Philips Pressurised steam generator GC8330/02 180 g steam boost 5 bar SteamGlide with Detachable water tank
GC8330/02

Service information

Reference no.: SDA_97593

1W and 0.5W Power Board and Control Board

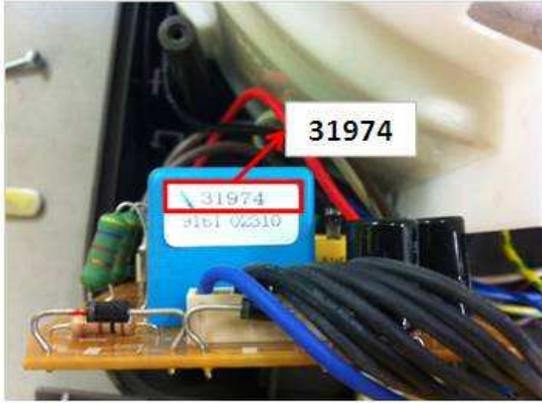
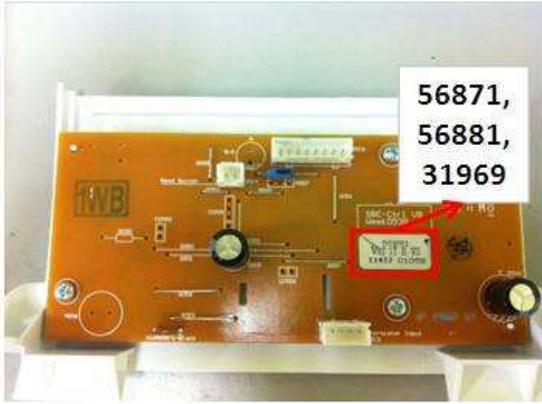
Typical symptoms or complaints: Service center have 2 type of Power Board (4239 021 31970) and (4239 021 73241)

Power Board PCB Assy upgraded from 1W to 0.5W standby power..

CTN	Return set GC82xx, GC83xx	Repair option
GC82xx, GC83xx	**If Control Board PCBA Assy (Pos 44) is 4239 021 56871 or 4239 021 56881 or 4239 021 31969	Option 1* Pos 43: Replace Power Board PCBA Assy, 4239 021 31970 Option 2 (Must replace both Power Board and Control Board) Pos 43: Replace Power Board PCBA Assy, 4239 021 73241 and Pos 44: Replace Control Board PCBA Assy, 4239 021 73231
	If Control Board PCBA Assy (Pos 44) is 4239 021 73231	Option 3 Pos 43: Replace Power Board PCBA Assy, 4239 021 73241

* If Repair Option 1 Power Board PCBA Assy, 4239 021 31970 is not available, pls use Repair Option 2.

Power Board	Control Board
OLD	 <p>31974</p> <p>31974 3161 02310</p>	 <p>56871, 56881, 31969</p>
NEW	 <p>73241</p> <p>31977 12091902550</p>	 <p>73231</p>
